**UNIFORM STANDARD DRAWINGS
CLARK COUNTY AREA**

VOLUME I - YEAR 2008 REVISIONS

| SPECIFICATION REFERENCE | | UNIFORM STANDARD DRAWINGS CLARK COUNTY AREA | |
|-------------------------|---------------------|--|----------------|
| | | DATE 3-13-08 | DWG. NO. 234.2 |

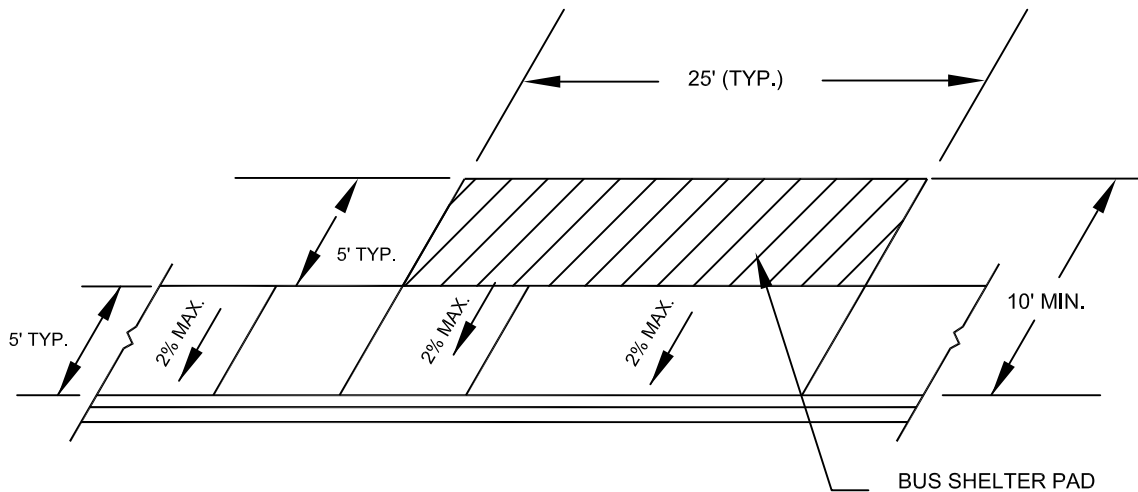
| Drawing Number | Title | Nature of Change | Effective Date |
|-----------------------|--|--|-----------------------|
| 234.2 | "Typical Bus Stop Passenger Loading and Shelter Pads" | Revision to Accommodate the New Bus Shelter Design and Improve Americans with Disabilities Act (ADA) Requirements. | 07/01/08 |

| SPECIFICATION REFERENCE | | UNIFORM STANDARD DRAWINGS CLARK COUNTY AREA | |
|-------------------------|---------------------|---|-----------------|
| | | DATE 3-13-08 | DWG. NO. 234.2A |

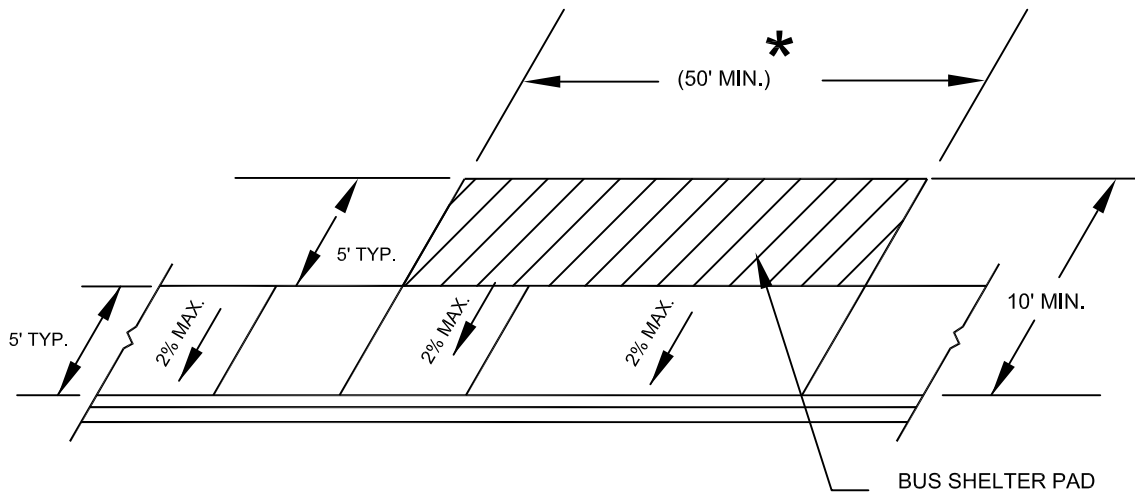
| Drawing Number | Title | Nature of Change | Effective Date |
|-----------------------|--|--|-----------------------|
| 234.2A | "Typical Double Bus Stop Passenger Loading and Shelter Pads" | Revision to Accommodate the New Bus Shelter Design and Improve Americans with Disabilities Act (ADA) Requirements. | 07/01/08 |

| DATE 11-8-07 | DWG. NO. 235 | (1 OF 4) | |

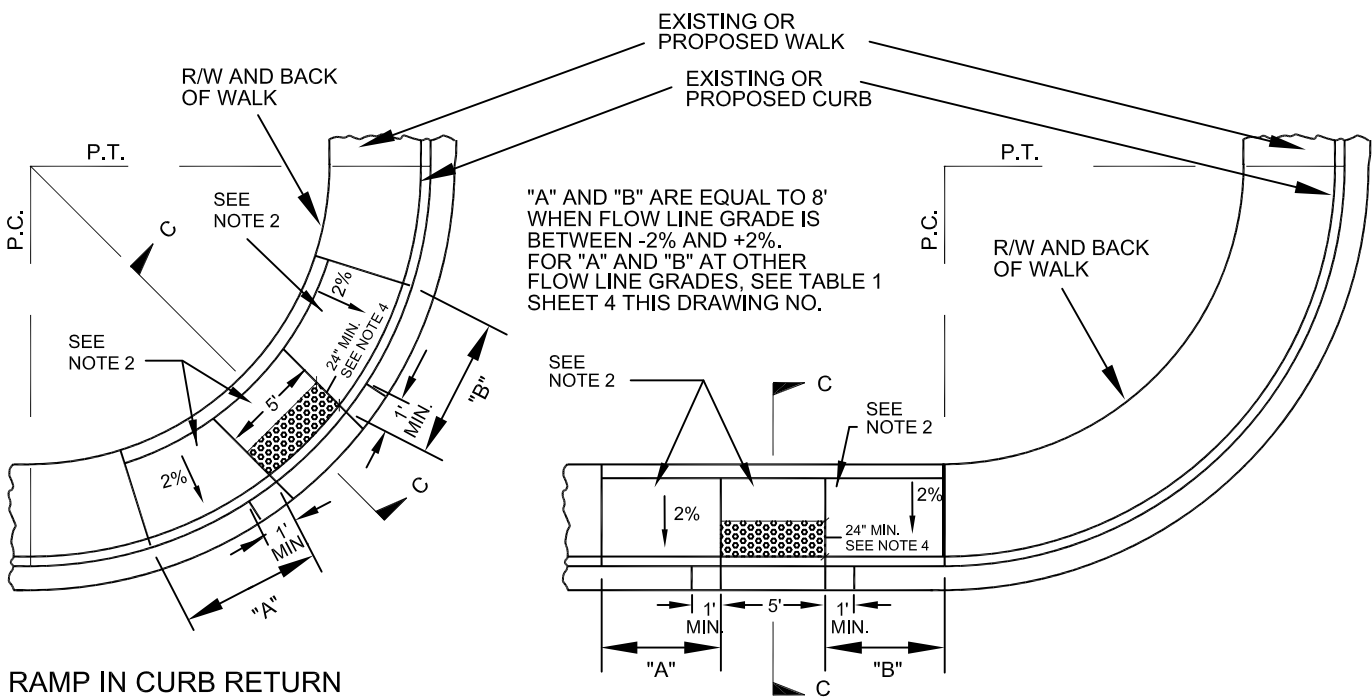
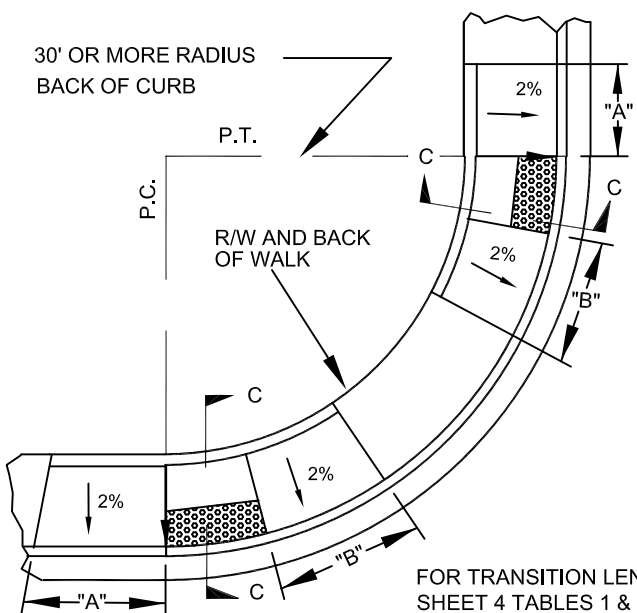
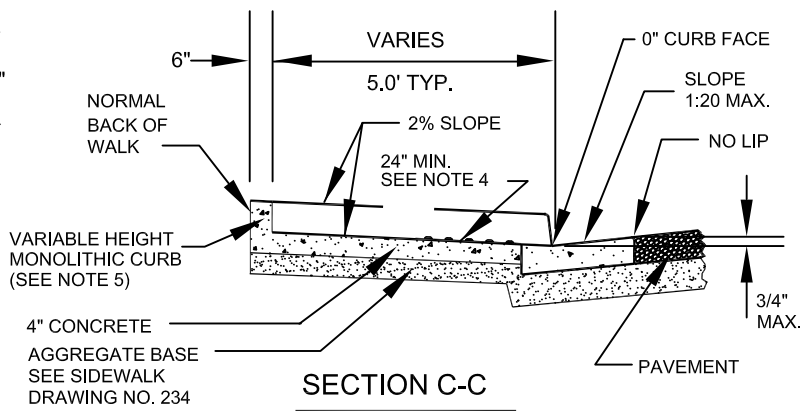
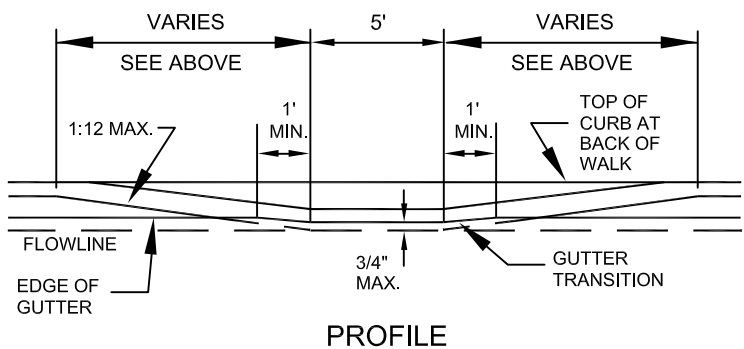
| Drawing Number | Title | Nature of Change | Effective Date |
|-----------------------|--|--|-----------------------|
| 235 (Sheet 1 of 4) | "Sidewalk Ramp Case I" | Revision to add 'Paired Ramp in Curb Return' to comply with current American with Disabilities Act (ADA) requirements. | 01/01/08 |

| DATE | 7-12-07 | DWG. NO. | 256.4 | PAGE NO. | 59.25 |

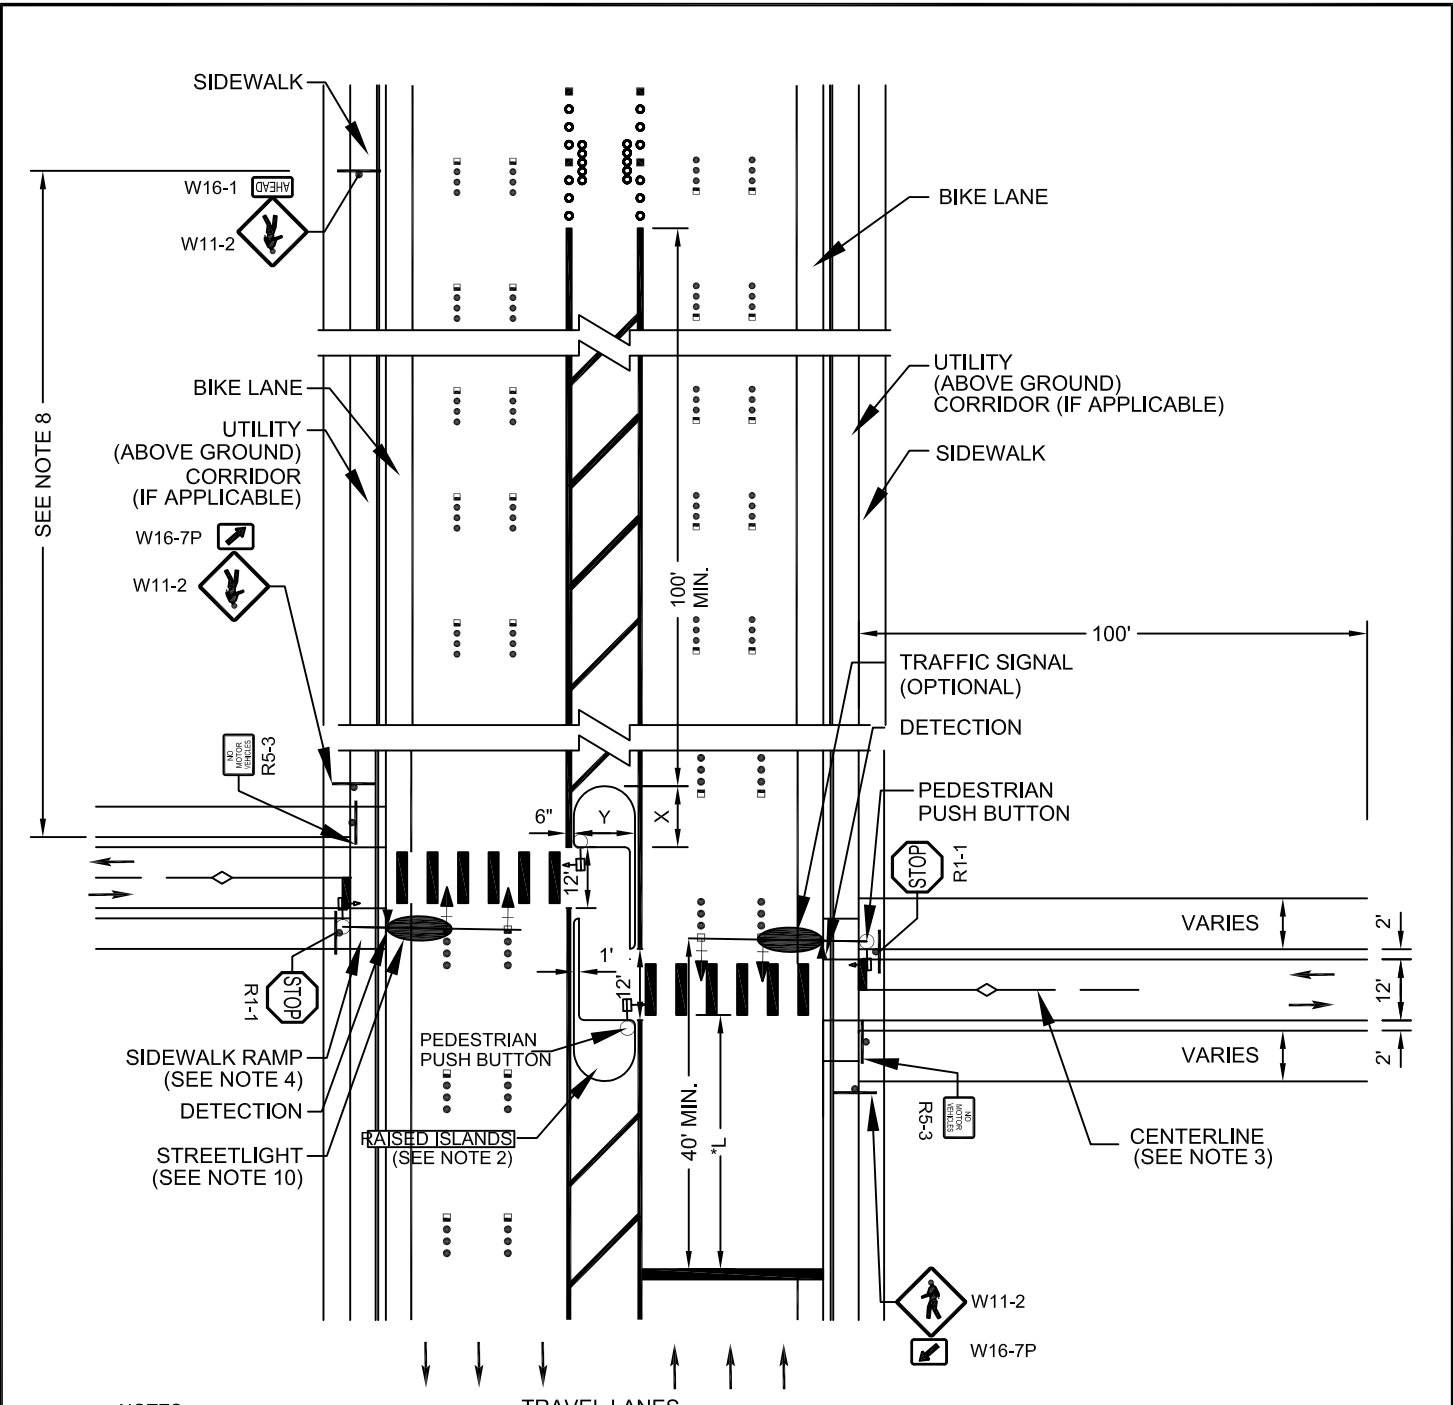
| Drawing Number | Title | Nature of Change | Effective Date |
|-----------------------|--|--|-----------------------|
| 256.4 | "Shared Use Path Crossing 6 Lane Roadway" | Revision to reduce the 504 feet of restricted crossing to 100 feet for improved access management. | 01/01/08 |

| SPECIFICATION REFERENCE | | UNIFORM STANDARD DRAWINGS CLARK COUNTY AREA | | | |
|-------------------------|----------------------------------|--|---------|----------|-----|
| | | DATE | 2-08-07 | DWG. NO. | 303 |

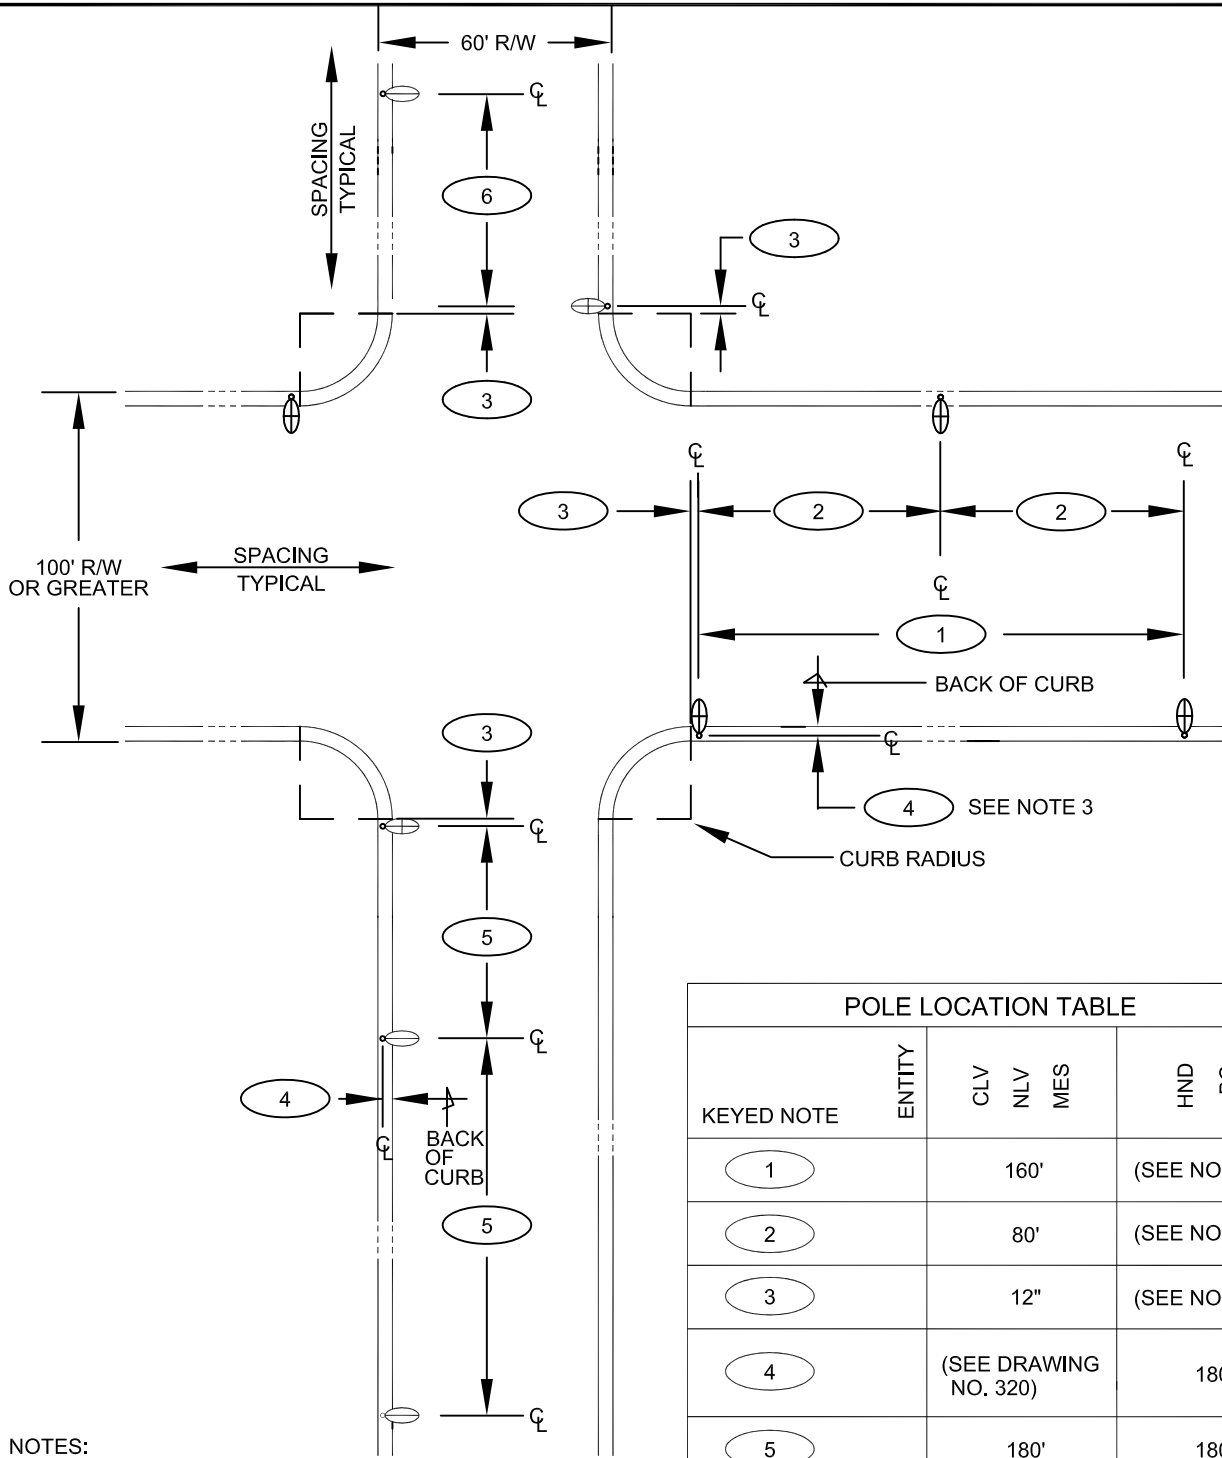
| Drawing Number | Title | Nature of Change | Effective Date |
|-----------------------|--|--|-----------------------|
| 303 | "Streetlight Locations at Intersections 100' or Greater/60' Right-of-Way (Except Clark County)" | Revision to correct editorial error in the pole location table. | 01/01/08 |

| SPECIFICATION REFERENCE | | UNIFORM STANDARD DRAWINGS CLARK COUNTY AREA | |
|-------------------------|----------------------------------|--|--------------|
| | | DATE 2-08-07 | DWG. NO. 304 |

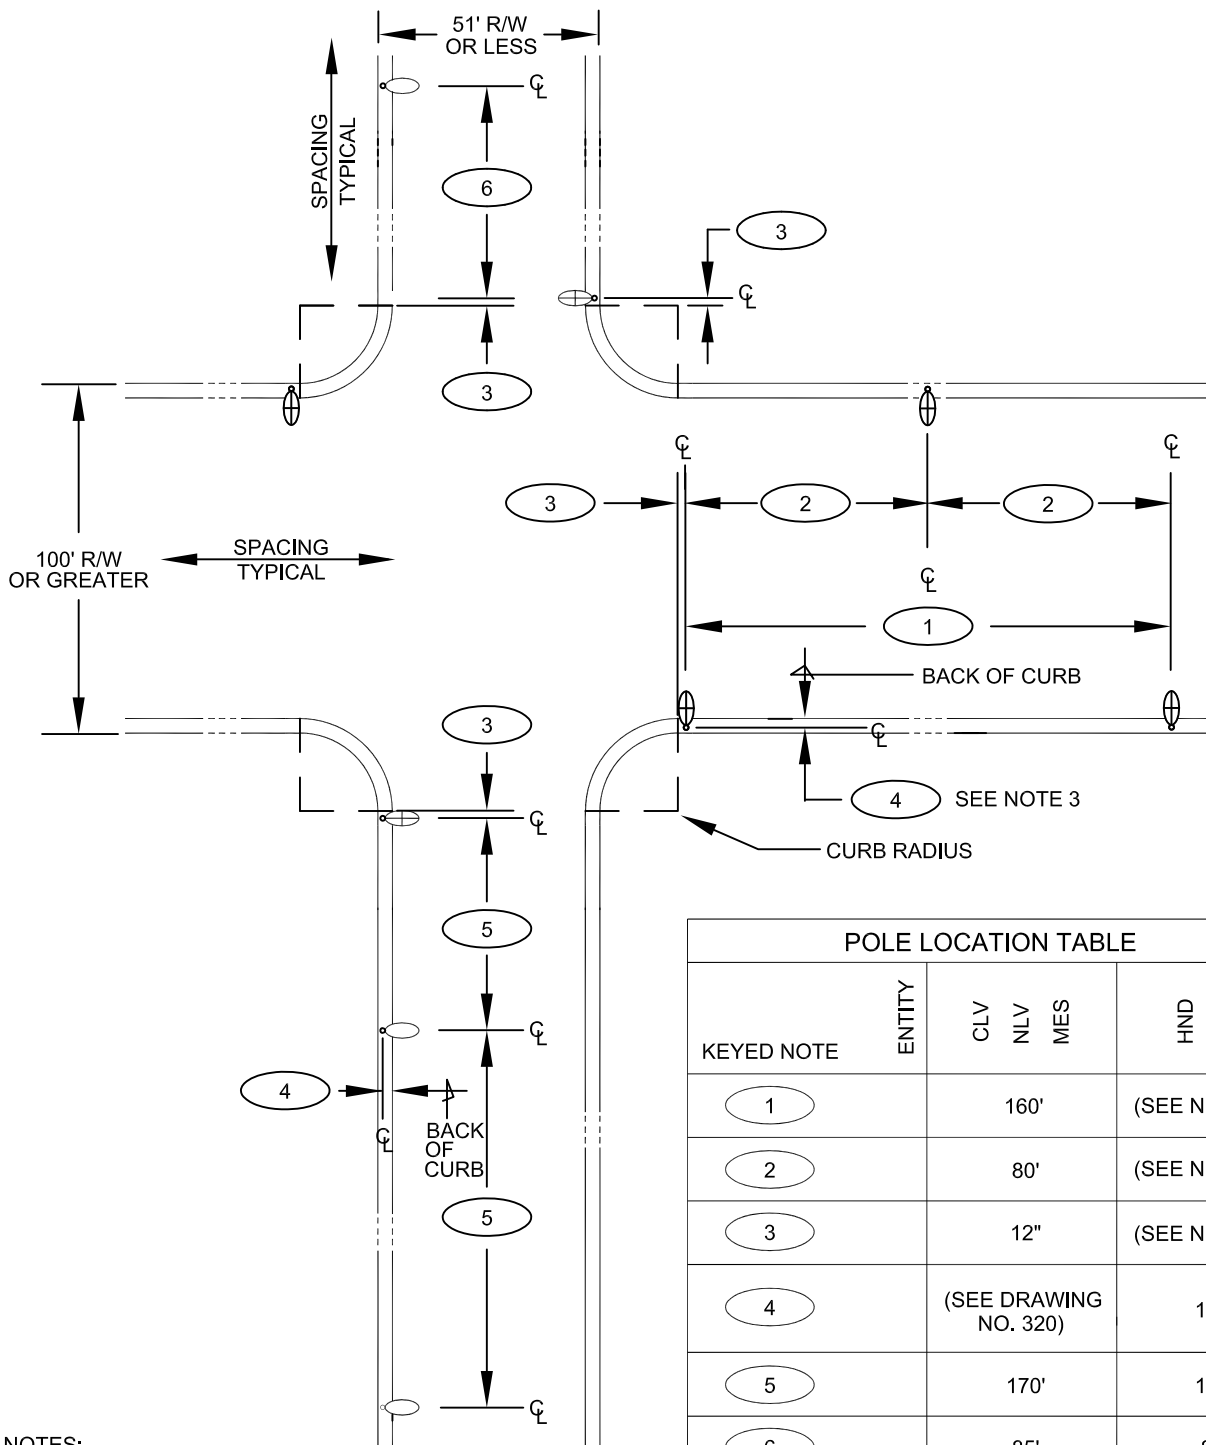
| Drawing Number | Title | Nature of Change | Effective Date |
|-----------------------|--|--|-----------------------|
| 304 | "Streetlight Locations at Intersections 100' or Greater/51' or Less Right-of-Way (Except Clark County)" | Revision to correct editorial error in the pole location table. | 01/01/08 |

| | | DATE 6-12-08 | DWG. NO. 500AL | SHEET 1 OF 2 |

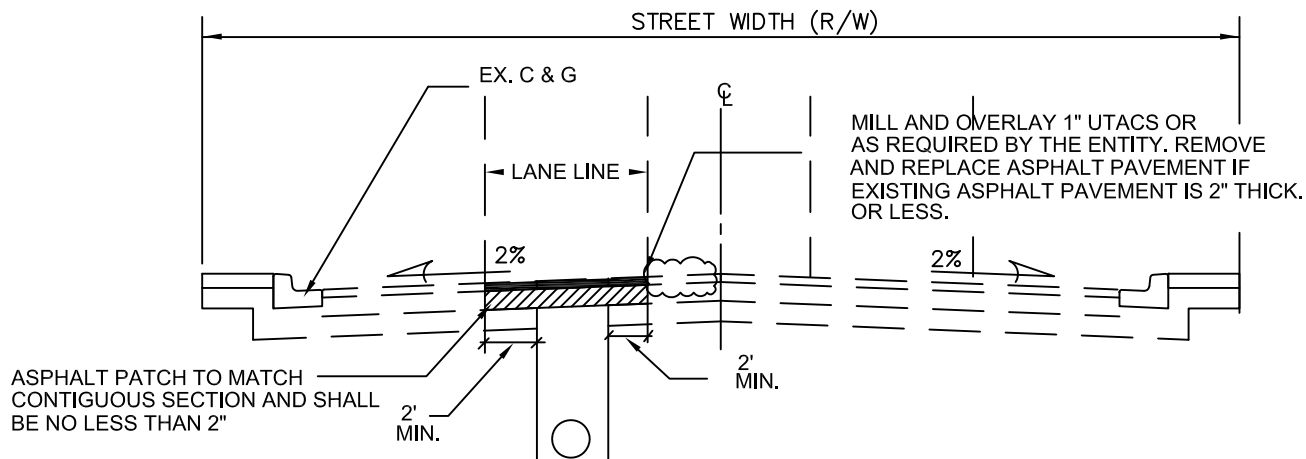
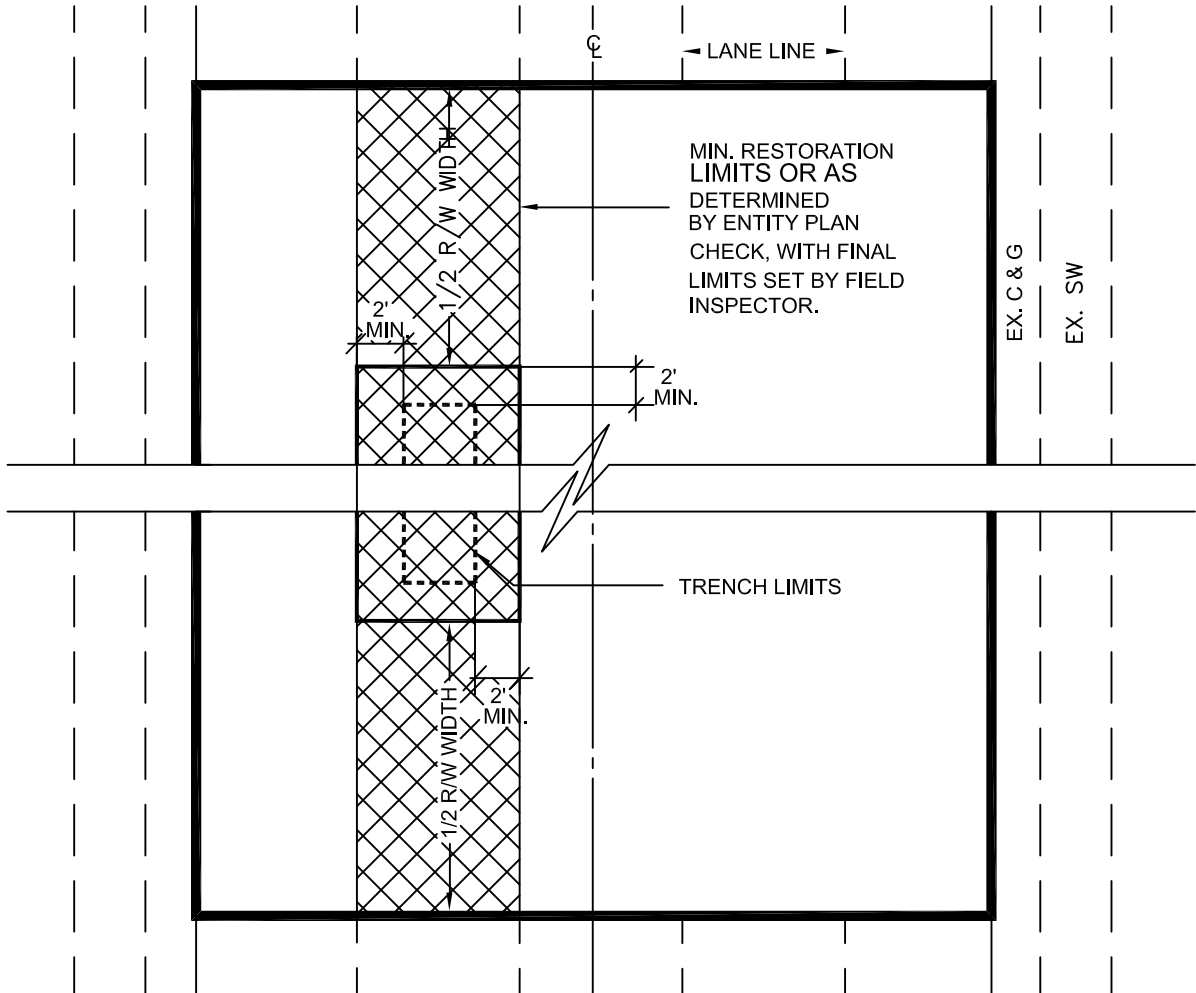
| Drawing Number | Title | Nature of Change | Effective Date |
|-----------------------|--|--|-----------------------|
| 500AL | "0 To 5 Years Pavement Restoration Longitudinal Cut" | Addition to incorporate new Standards from the Recommendations of the recent pavements cut study and trench working group. | 07/01/08 |
